**CITY OF GAINESVILLE PLANNING DIVISION  
SUMMARY OF COMMENTS**

<b>Petition Number: 99SUB-05 DB</b>	<b>Reviewed by: Gene G. Francis</b>
<b>Development Review Board Meeting: July 14, 2005</b>	
<b>Project Name/Description: Hampton Lane Subdivision</b>

Petition No. <u>99SUB-05DB</u>	Date Plan Rec'd: <u>07/01/05</u>	Review Type: <u>Design Plat</u>
Review For: <u>Development Review Board</u>	Review Date: <u>07/14/05</u>	Project Agent:
Description, Agent & Location: <u>Hampton Lane Subdivision</u>		<u>Causseaux &amp; Ellington</u>

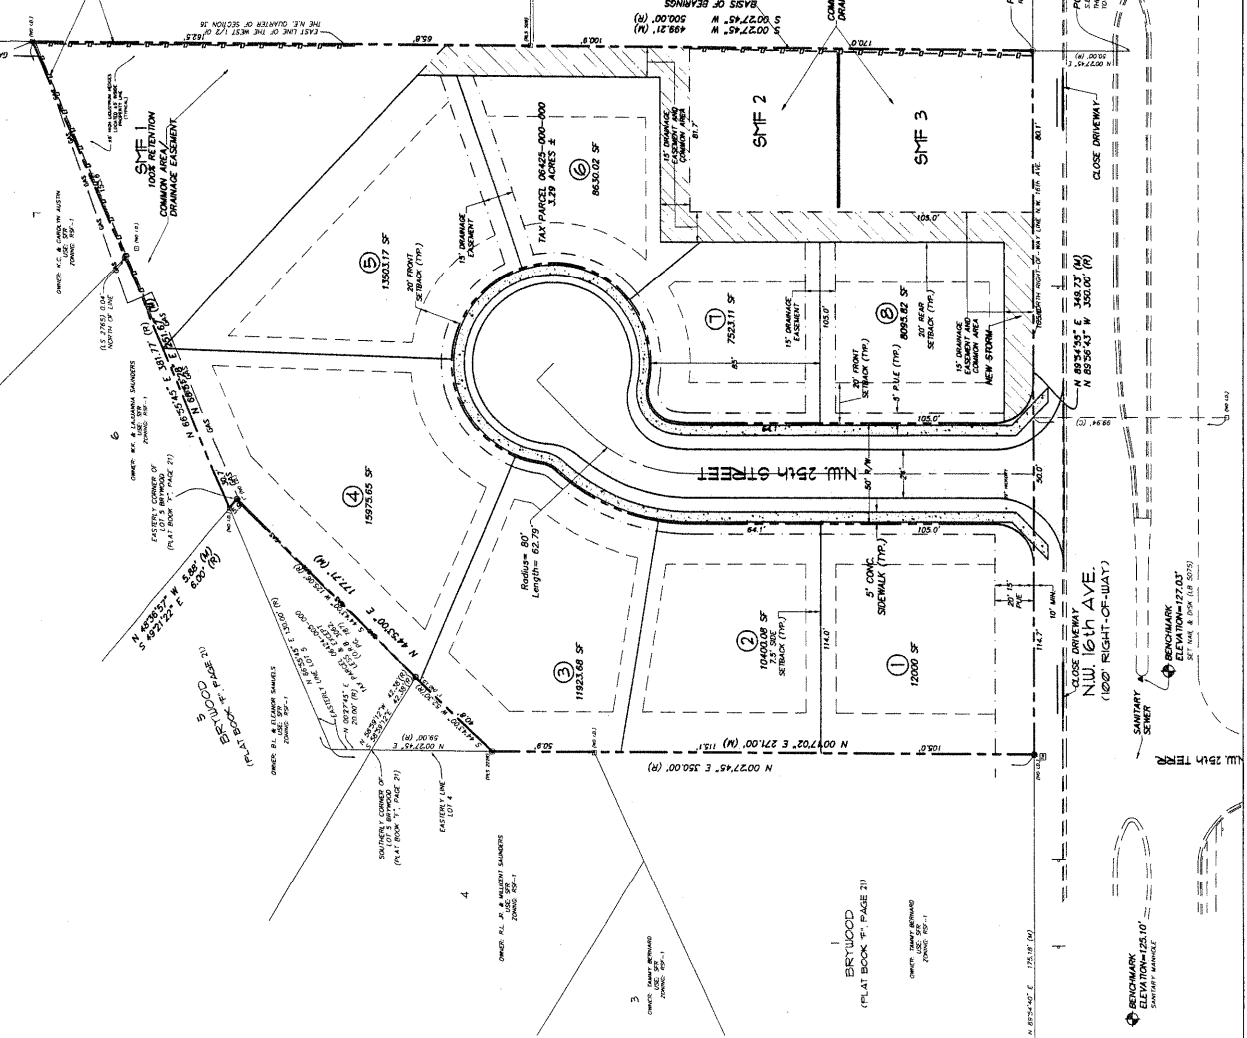
The petitioner must indicate on the "Final Plat" that Lots # 1 & 9 shall not have direct access to NW 16<sup>th</sup> Avenue.

5. As part of their construction plans, the petitioner must provide a landscape plan that indicates street shade trees that are placed every 50 feet on both sides of the right-of-way. In addition, the landscape should clearly illustrate (3) well landscaped stormwater retention basins.

6. Planning staff failed to comment on the lack of a 5-foot wide sidewalk being installed along the full length of the subdivision right-of-way. Planning staff is definitely calling for sidewalks to be installed and they should be indicated prior to the Design Plat going to the City Commission for their approval.

1. These basins appear small and tight to provide practical access at the rear of basins 1 & 2?
2. Please provide details of your flood route concept. This has become a very important issue as of late. We are now requiring a detailed concept at this stage.
3. See item #2.
4. I understand it is conceptual. We are just trying to clarify the existing system components vs. new system components.
5. Does this mean there is no access between basins?
6. Is this all the info you have on it?
7. Ok
8. Ok

1. Maintenance access required to drainage structures.
2. Provide flood routing for all basins.
3. plain discharge onto adjacent private property?
4. Provide more detail for existing (and proposed) drainage structures shown.
5. What is the structure between basins SMF 2 & 3?
6. Explain separate landlocked parcel in NW corner of site?
7. Show radius of curve in roadway.
8. Explain access plan for the median in NW 16th Avenue?

- There are several heritage and regulated Magnolia trees on site and protecting these trees would be a wise decision for the Urban Forest.
